Service - Info

Unit type : Chassis DTV 101

KD0002K

No.: 207

No.: 213

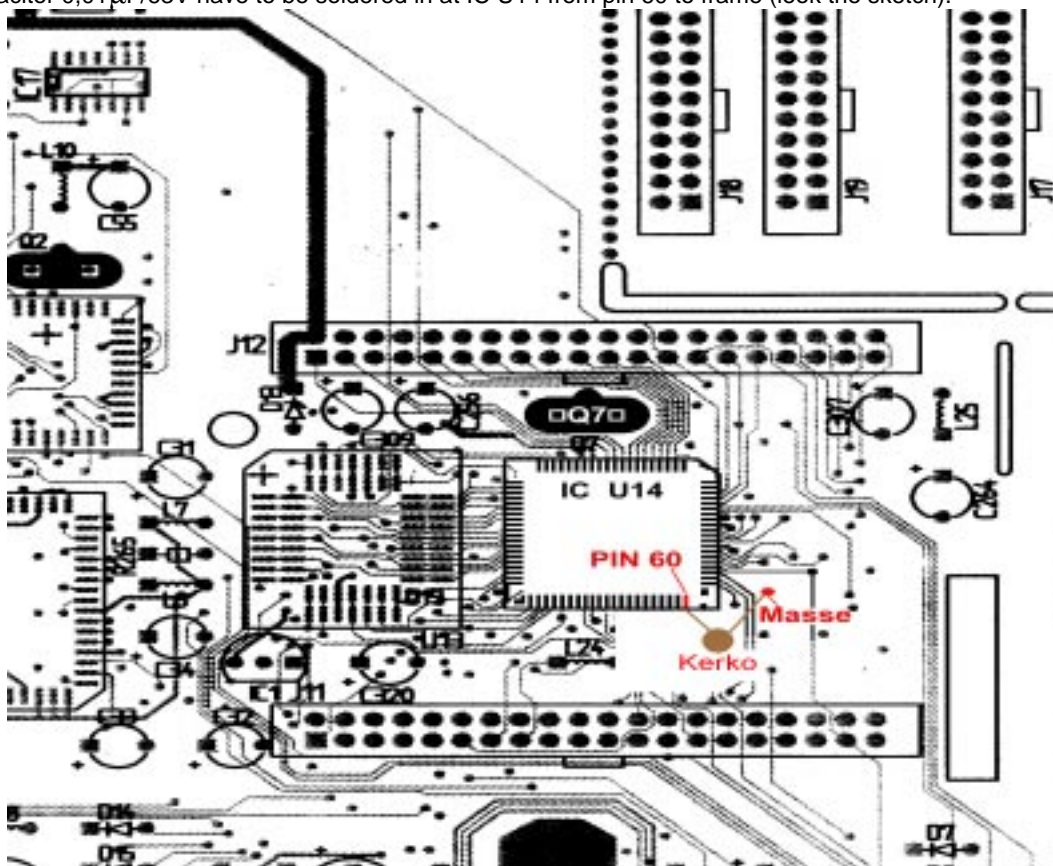
Disturbance at channel 4

- A capacitor 0,01 μ F/63V have to be soldered in at IC U14 from pin 60 to frame (look the sketch).

No.: 214

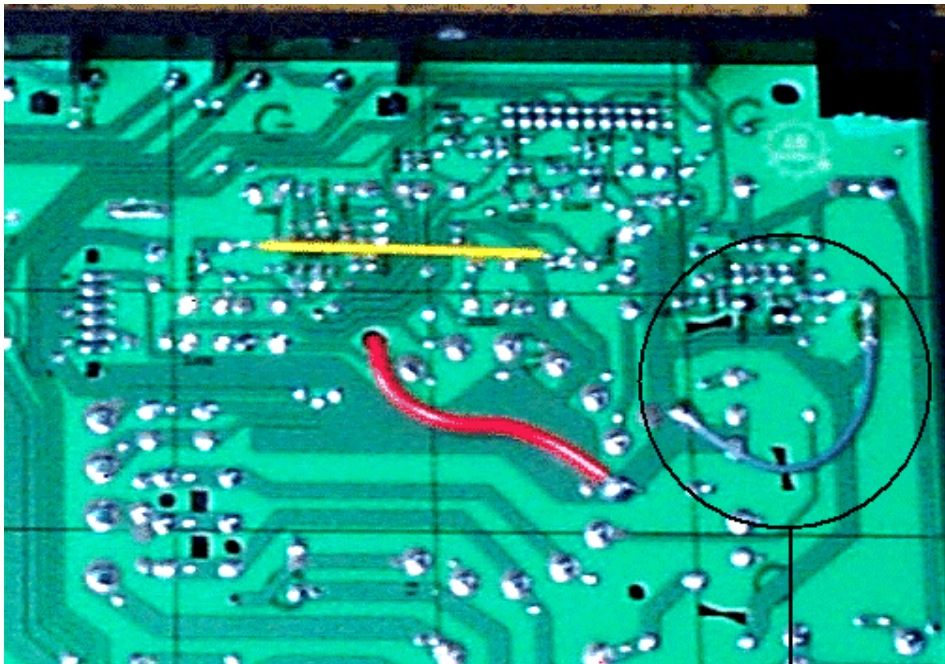
Vertical interference pattern

Extra frame connection cooling plate deflection (see illustration)

Frame connection
